June 3, 2014

State of Vermont Agency of Transportation  
Southwest Regional Construction Office  
61 Valley View  
Mendon, VT 05701

**Re: Rochester BRF 0162(16) & BRF 0162(17) & ER BRF 0162(18) & STP BRF 0162(19)  
Item 529.15 Removal of Structure – Demo Plan Bridge 15 & 16**

PROJECT NAME:	ROCHESTER	PLOT DATE:	9/3/2013
PROJECT NUMBER:	BRF 0162(17)	DRAWN BY:	E.A. FIALA
FILE NAME:	z85e035pe.dgn	DESIGNED BY:	G.S. GOODRICH
PROJECT LEADER:	G.S. GOODRICH	CHECKED BY:	S.E. BURBANK
BR 16 PLAN AND ELEVATION (BRIDGE)		SHEET 146 OF 238

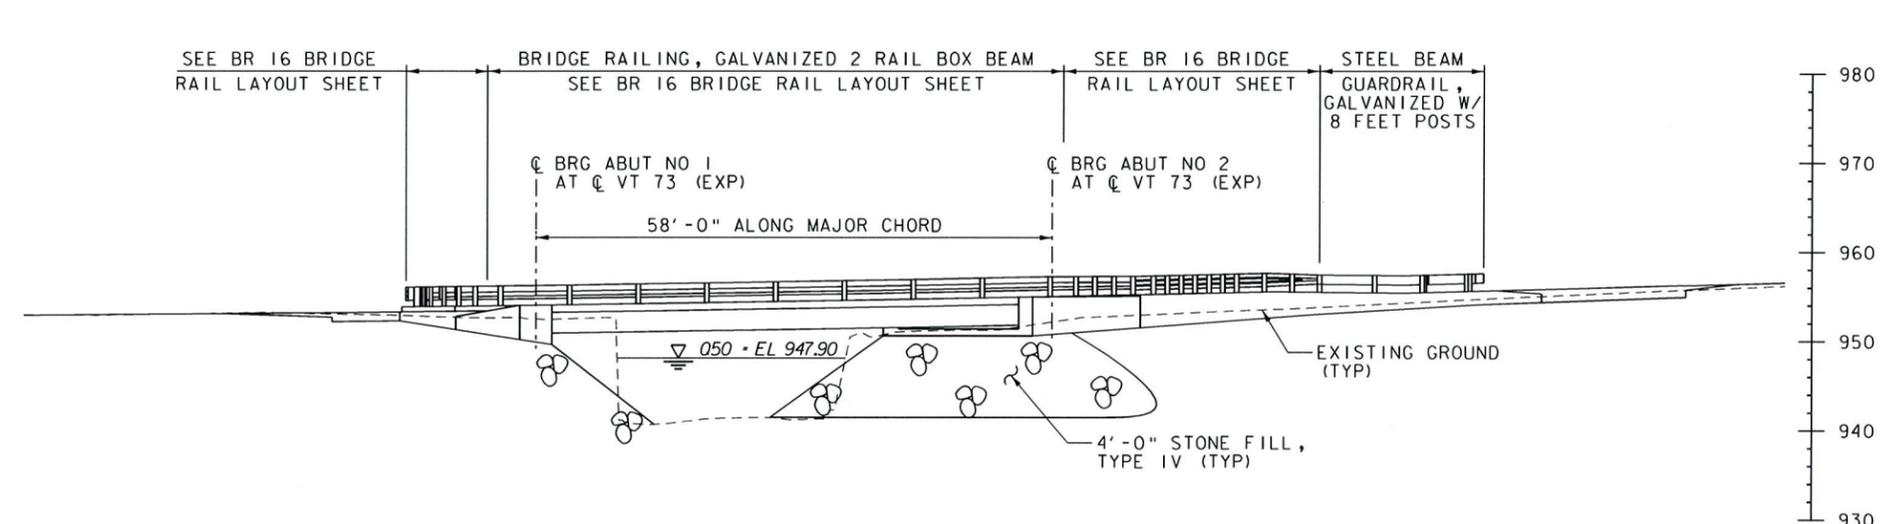
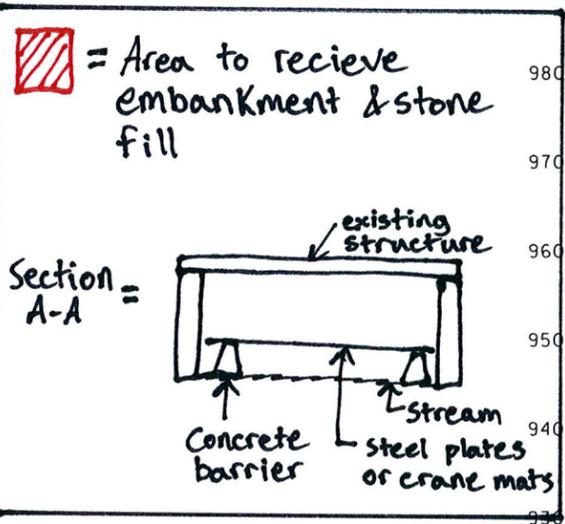
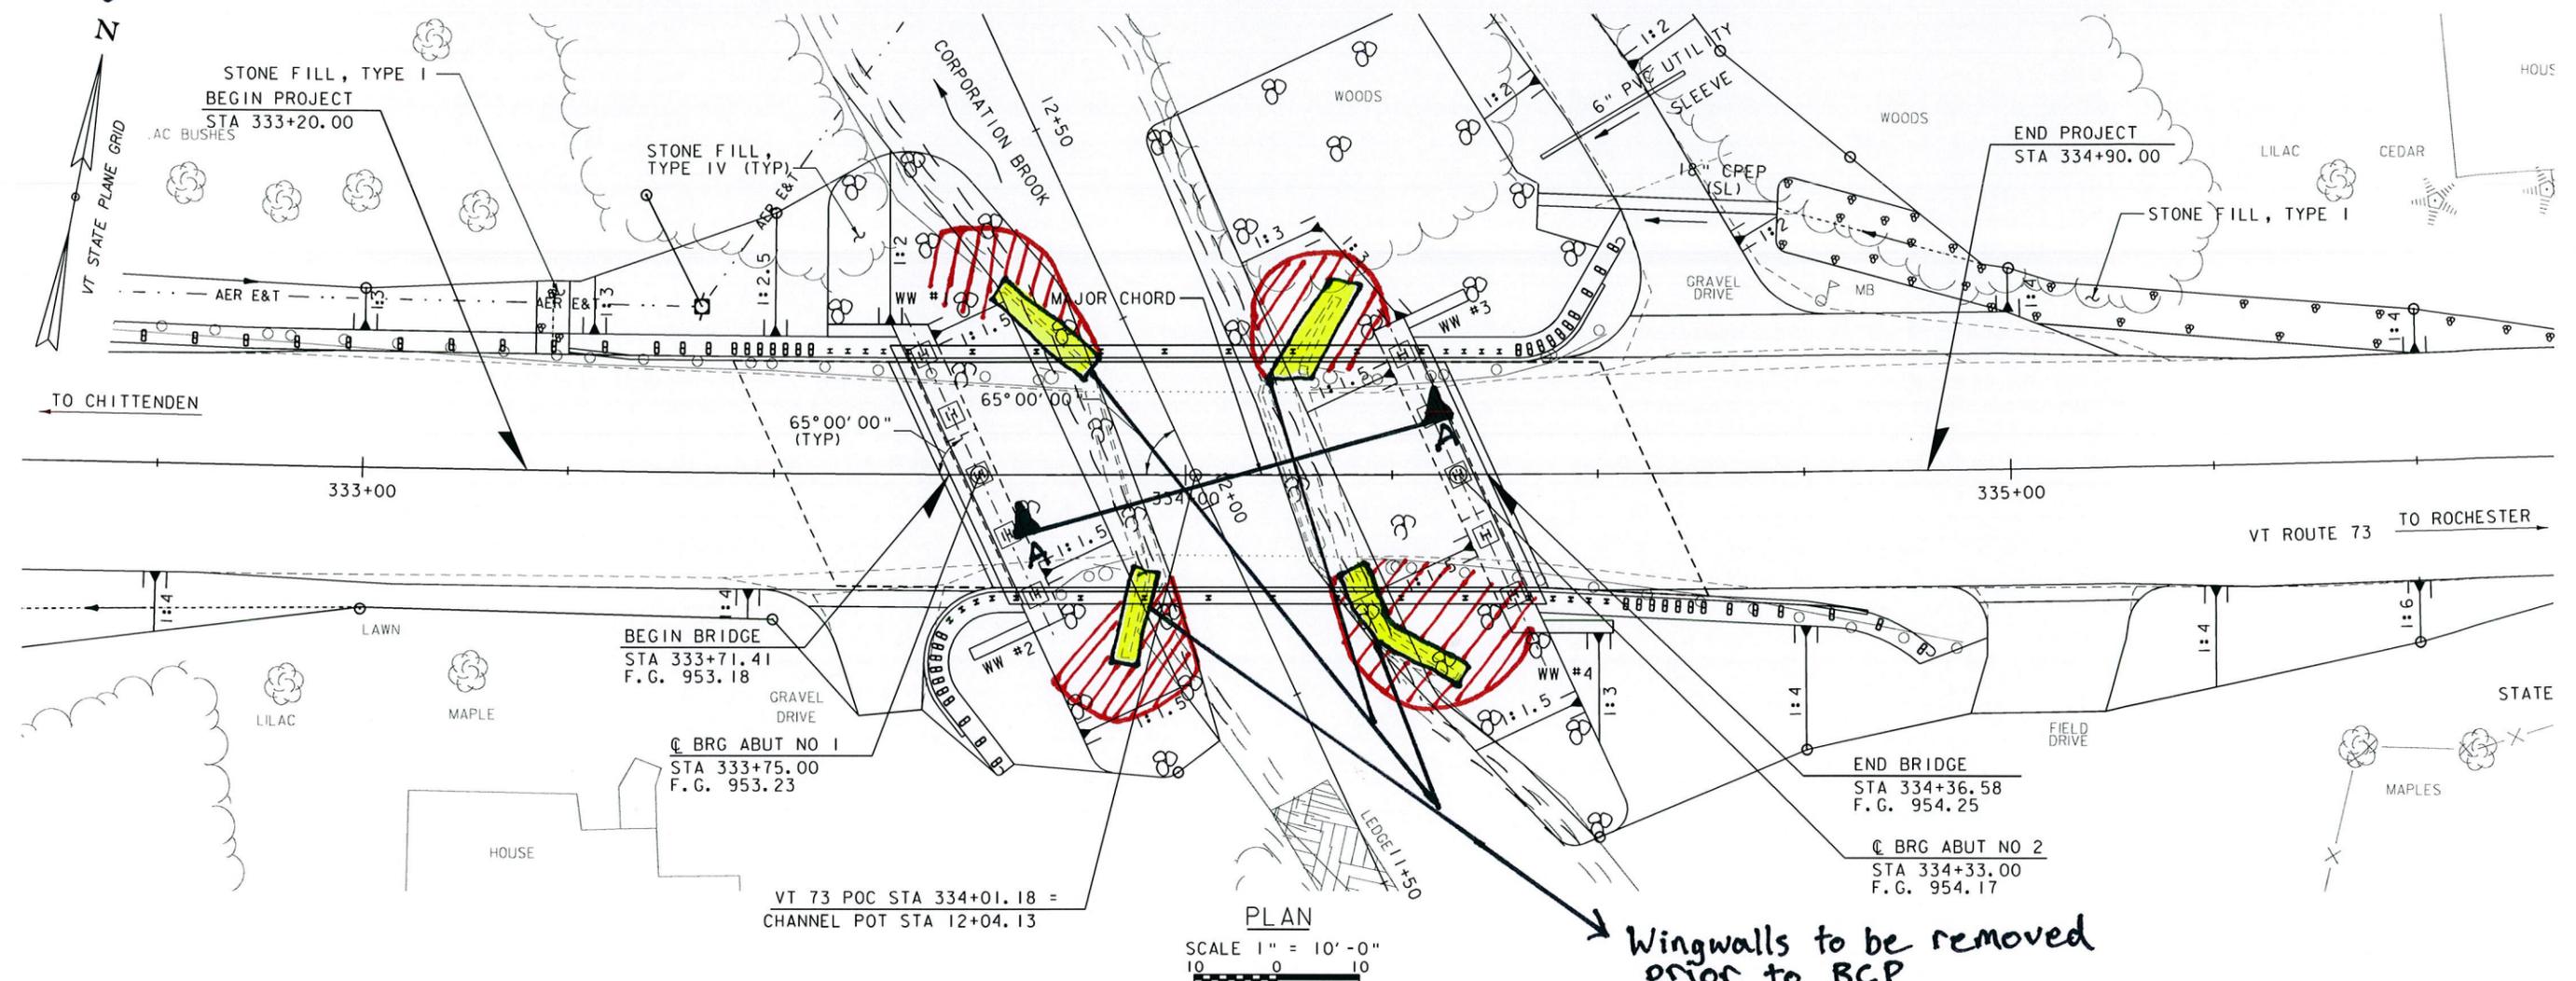
Bridge 16: At this location we plan to remove all wingwalls in similar fashion to what is described above for Bridge 15. Our intent is to setup a temporary lane closure to push traffic to the opposite side from where the removal is occurring. As with bridge 15, we will drill a series of 1-1/2" to 2" diameter holes at 2ft on center and break off the wingwalls using either a rock splitter or a hydraulic hammer. We will then place embankment at a 1:1 slope coming off the road with stone fill placed on top to stabilize the slope and prevent scour. Once both wingwalls are removed on one side the traffic pattern will be flipped and the other side will be removed using the same means and methods. Again, as with bridge 15, we will then predrill one

horizontal row and four to five vertical rows of 1-1/2" to 2" holes at 2ft on center in the abutments to allow break points for rock splitters and/or hydraulic hammers during the BCP. Finally, we will setup concrete barrier parallel to the flow with steel road plates or crane mats on top of them prior to the BCP, these will prevent material from entering the stream below (a stream diversion plan will be submitted under separate cover for this setup).

Attached hereto are some marked up plan sheets for each of these structures highlighting portions of what is described above. Please review this plan and contact me should you have any questions. Thank you.

PROJECT NAME: ROCHESTER	PLOT DATE: 9/3/2013
PROJECT NUMBER: BRF 0162(16)	DRAWN BY: J. D. KEENER
FILE NAME: z10c418bdr_utility.dgn	CHECKED BY: S. E. BURBANK
PROJECT LEADER: G.S. GOODRICH	DESIGNED BY: CMP
BR 15 DRAINAGE & UTILITY LAYOUT SHEET	SHEET 78 OF 238

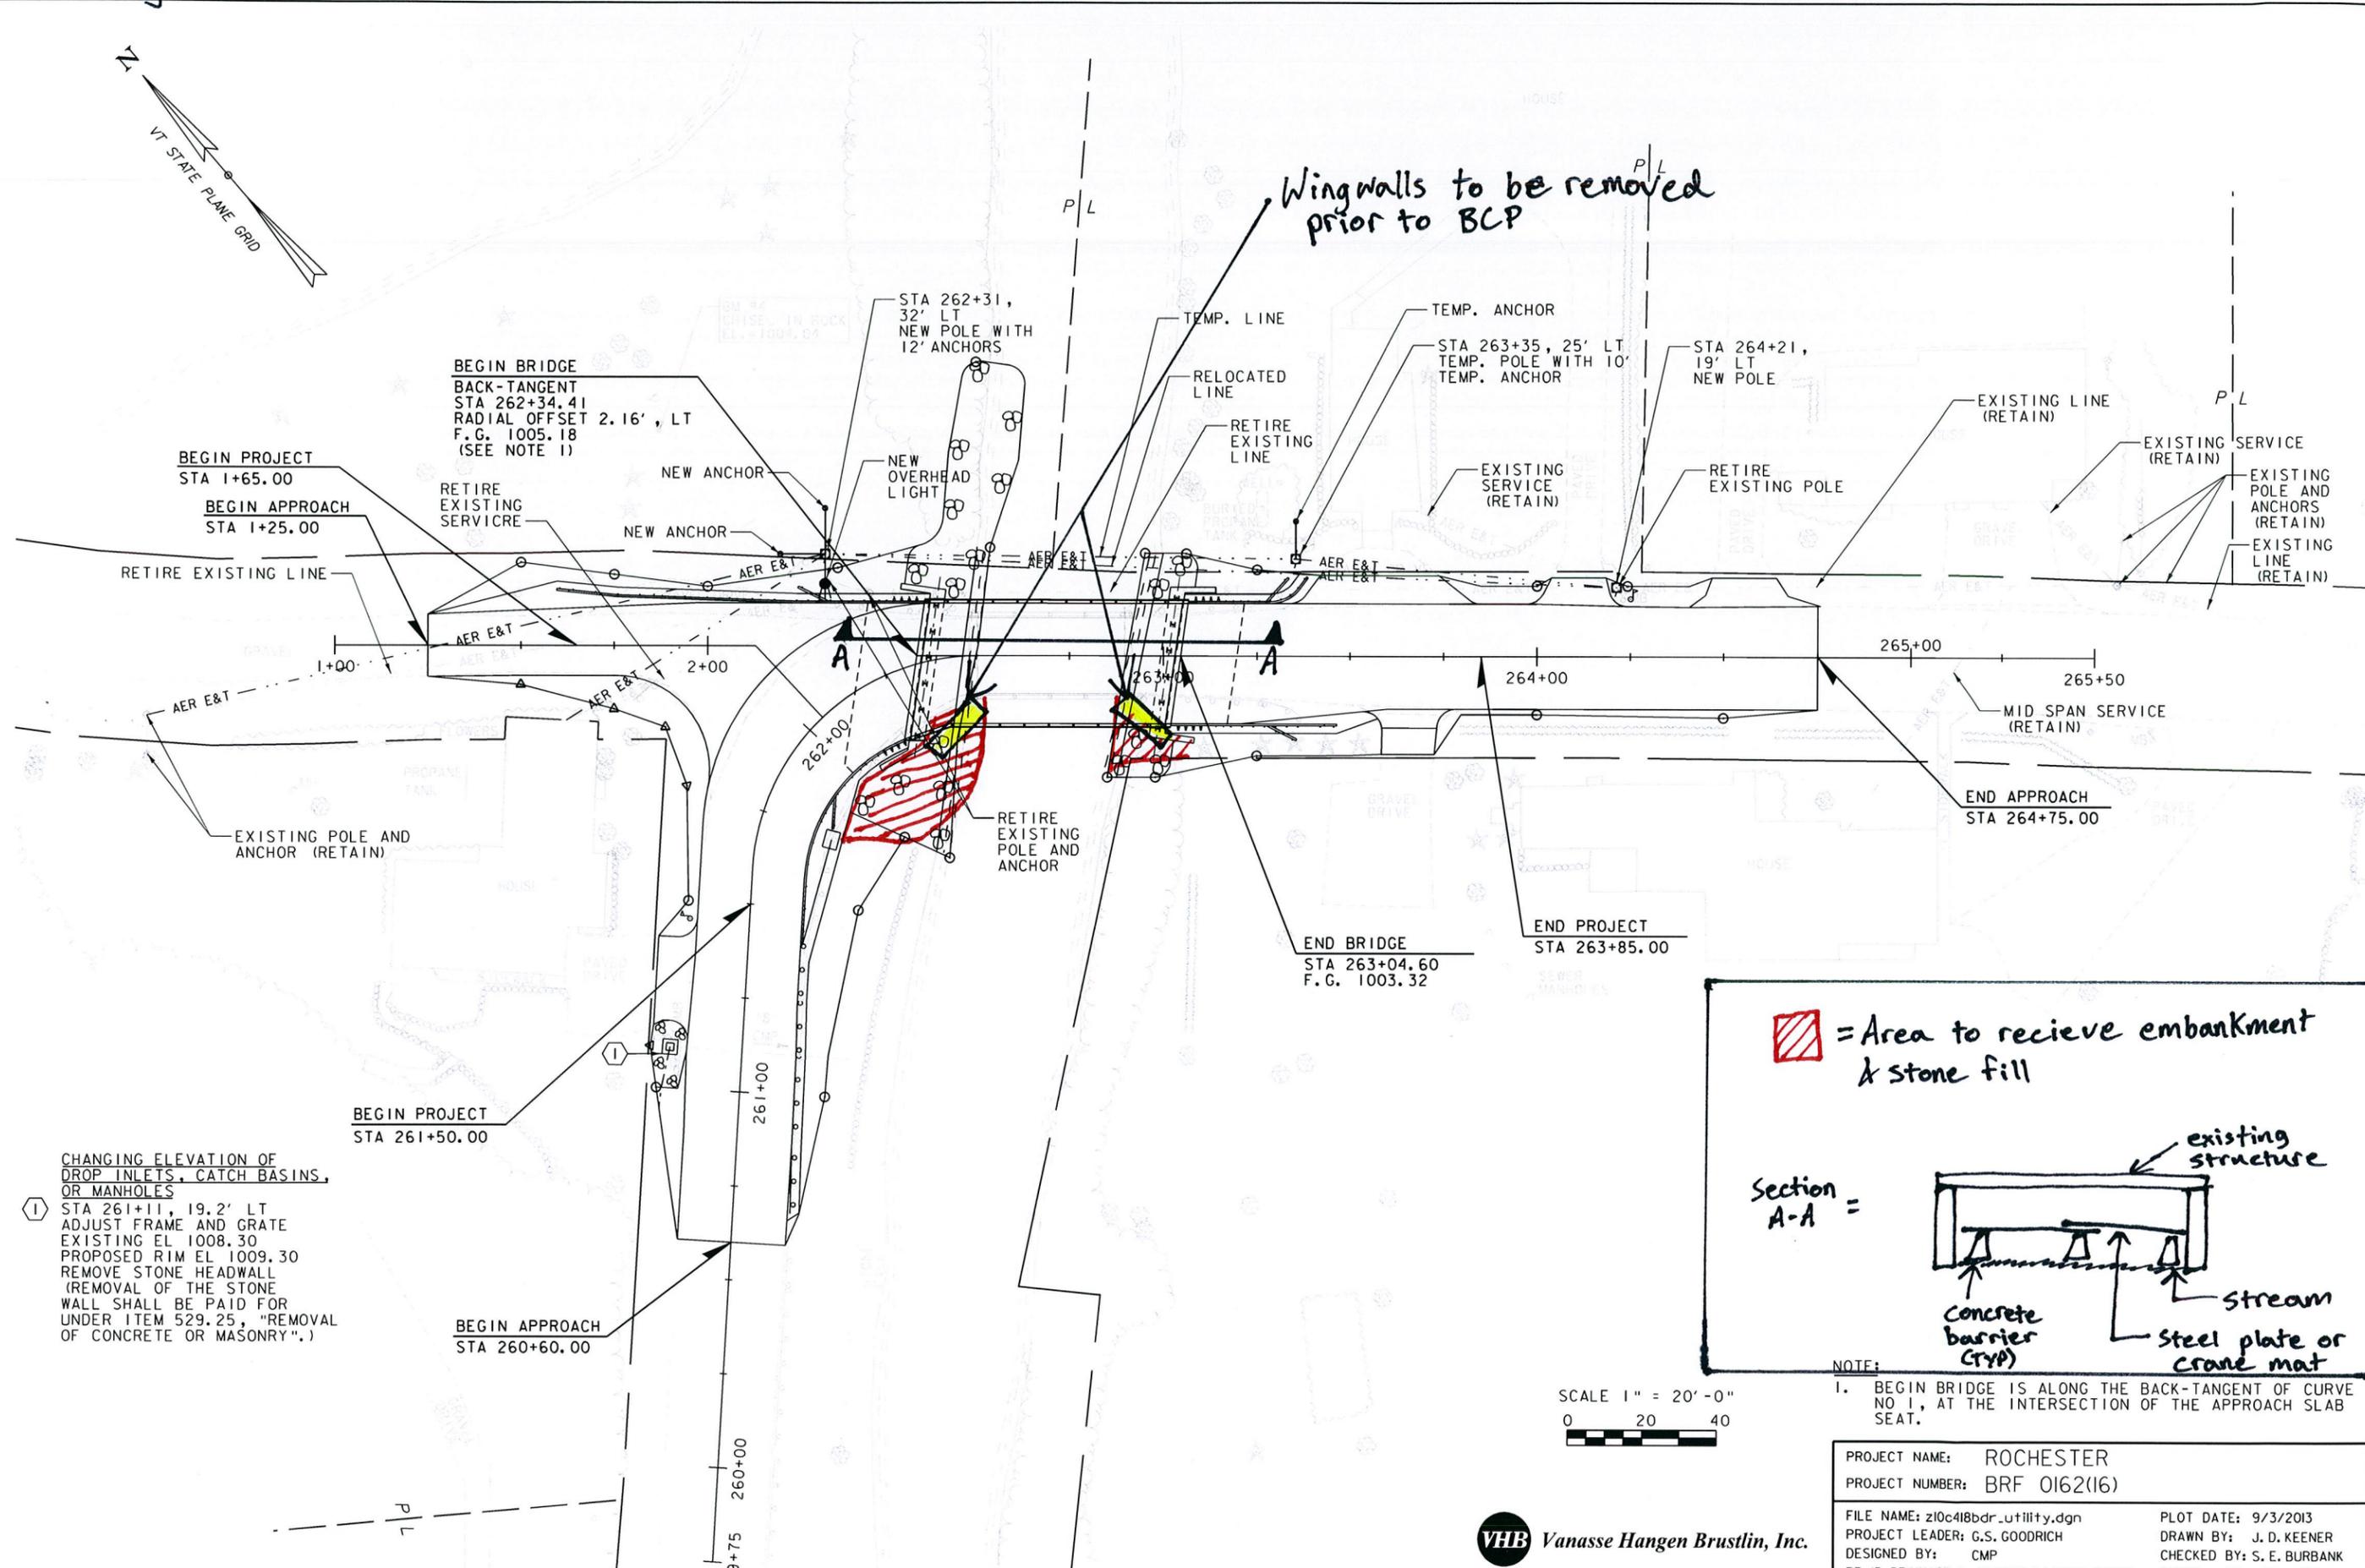
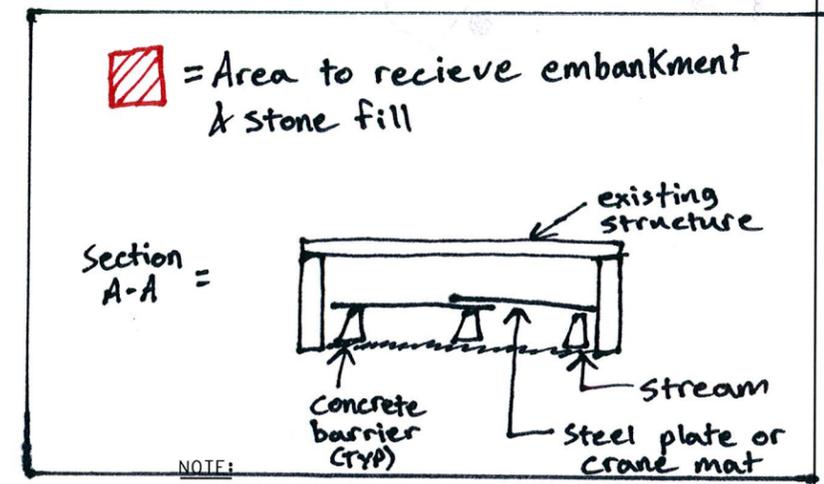
Bridge 15: Both of the southern wingwalls have potential conflicts with piles that can be installed prior to the BCP and therefore it is our intention to remove them in advance. Our intent is to set up a temporary lane closure and the approved truck detour, drill a vertical series of 1-1/2" to 2" diameter holes at 2ft on center, and break them off using either a rock splitter or hydraulic hammer. In removing the wingwalls we will also clear out and remove any large boulders or cobbles that may interfere with the piles. Prior to reopening the road, embankment material will be placed at a 1:1 slope coming off the road with stone fill placed on top to stabilize the slope and prevent scour. These two wingwalls are the only pieces of the structure we plan to remove in advance of the closure. However we do intend to predrill one horizontal row and four to five vertical rows of 1-1/2" to 2" holes at 2 ft on center in the northern wingwalls and abutments to allow break points for rock splitters and/or hydraulic hammers during the BCP. In preparation of the demolition of the complete structure during the BCP, we intend to setup concrete barrier parallel to the flow with steel road plates or crane mats on top of them prior to the BCP, these will prevent material from entering the stream below (a stream diversion plan will be submitted under separate cover for this setup).
